SERVICE INFORMATION LETTER

SIL # 170508-11-6557-7WD

SUBJECT: It has been determined that some Wencor PMA PN 11-6557-7()WD Bezel Assemblies shipped prior to February 27, 2017 may be defective. In particular the Lens may pop out during assembly or when impacted with a force less than 10 lbs.

Figure 2. Typical Installation of PMA PN 11-6557-7()WD Bezel Assembly

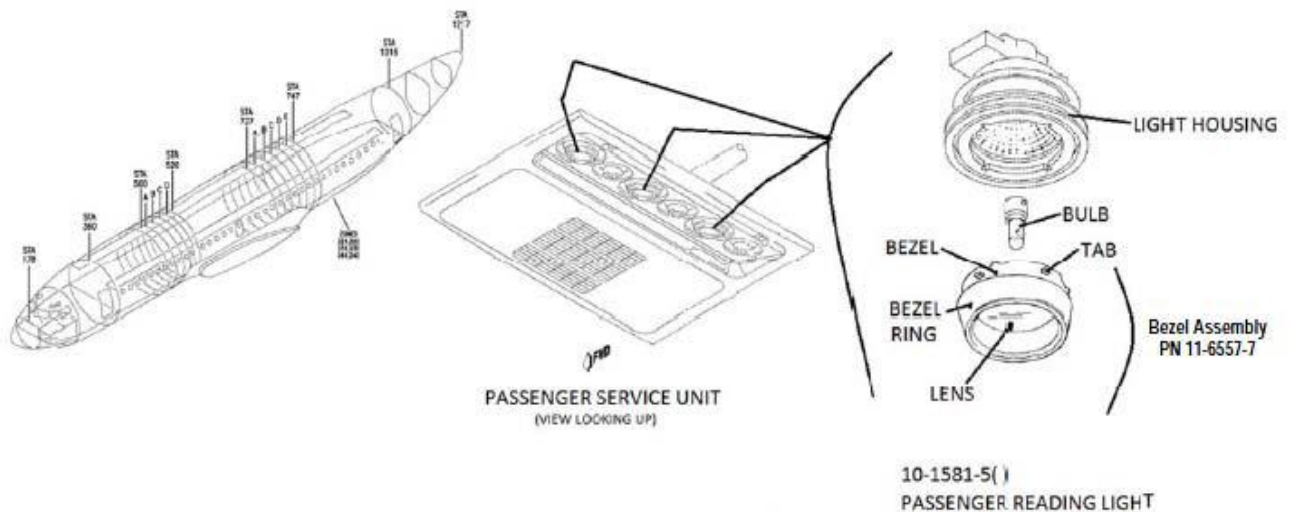
One customer has reported that the Lens on Wencor PMA PN 11-6557-7()WD Bezels have separated from the assembly during the installation on the aircraft. After investigating it has been determined that some PMA PN 11-6557-7()WD Bezels do not meet drawing requirements regarding workmanship with respect to adhesive application and Lens retention.

Lens detachment has been reported by one customer and was detected during installation. There have been no reports of this defect occurring after installation

Any Wencor PN 11-6557-7()WD Bezel Assemblies that are currently in service may remain in service at the discretion of the operator.

Any Wencor PN 11-6557-7()WD Bezel Assemblies that have not been installed may be returned to Wencor for credit or replacement as described in Section 4 below.
